SUBJECT: Savannah River Site's Responses to the Regulatory Comments on the Performance Evaluation Report for the A-Area Burning/Rubble Pits (731-A, -1A) and Rubble Pit (731-2A) and the Miscellaneous Chemical Basin/Metals Burning Pit (731-4A, -5A) Operable Unit - January through December 2023 (U) (SRNS-RP-2024-00115, Revision 0, May 2024) SEMS Number: 28

SRS Responses to U.S Environmental Protection Agency Comments on the Performance Evaluation Report for the A-Area Burning/Rubble Pits (731-A, -1A) and Rubble Pit (731-2A) and the Miscellaneous Chemical Basin/Metals Burning Pit (731-4A, -5A) Operable Unit – January through December 2023 (U), SEMS Number: 28 (SRNS-RP-2024-00115, Revision 0, May 2024)

Attachment 1. MAAZ Groundwater Monitoring Wells near the ABRP/MCB/MBP OU

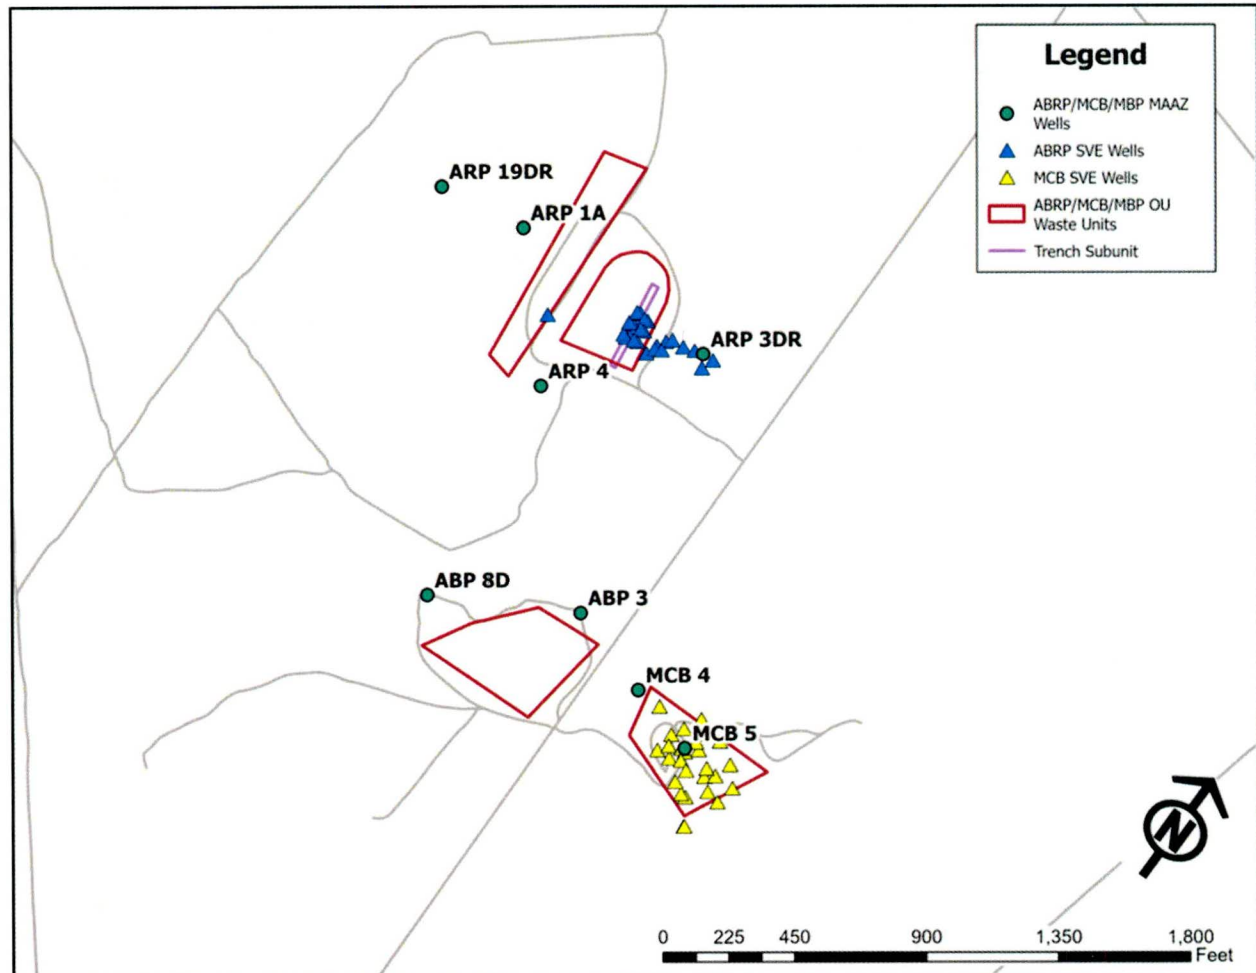
1. A figure depicting the locations of the M-Area Aquifer Zone (MAAZ) monitoring wells was not presented in the PER and the assertions in the text regarding contaminant concentrations and trends could not be evaluated. The PER discusses the monitoring wells screened in the water table aquifer MAAZ near the A-Area Burning/Rubble Pits and Rubble Pit (ABRP) and Miscellaneous Chemical Basin (MCB) source areas and indicates the wells have historically shown elevated levels of tetrachloroethylene (PCE) and trichloroethylene (TCE) contamination. The text also indicates MAAZ wells near the ABRP source have decreasing volatile organic compound (VOC) trends indicating mass depletion of the source; however, a figure depicting the locations of the MAAZ monitoring wells was not provided. While it is understood groundwater is not part of the ABRP/MCB/Metals Burning Pit (MBP) Operable Unit (OU), a figure depicting the monitoring wells discussed in the PER should be provided or a reference to where this information can be found should be provided. Please revise the PER to provide a figure depicting the monitoring wells discussed in the PER or provide a reference to where this information can be found.

Response: Agree with Clarification.

The media of concern for ABRP/MCB/MBP OU are surface and vadose zone soils. Groundwater is not part of the ABRP/MCB/MBP OU, and groundwater monitoring and corrective action are addressed under the RCRA Corrective Action Program per Core Team Agreement. The Annual 2023 M-Area and Metallurgical Laboratory Hazardous Waste Management Facilities Groundwater Monitoring and Corrective Action Report (U) (SRNS-RP-2023-01452, March 2024) is the current groundwater report that discusses the MAAZ wells. The groundwater monitoring and corrective action report is published annually in March. A reference to the most recent report will be included in the next PER.
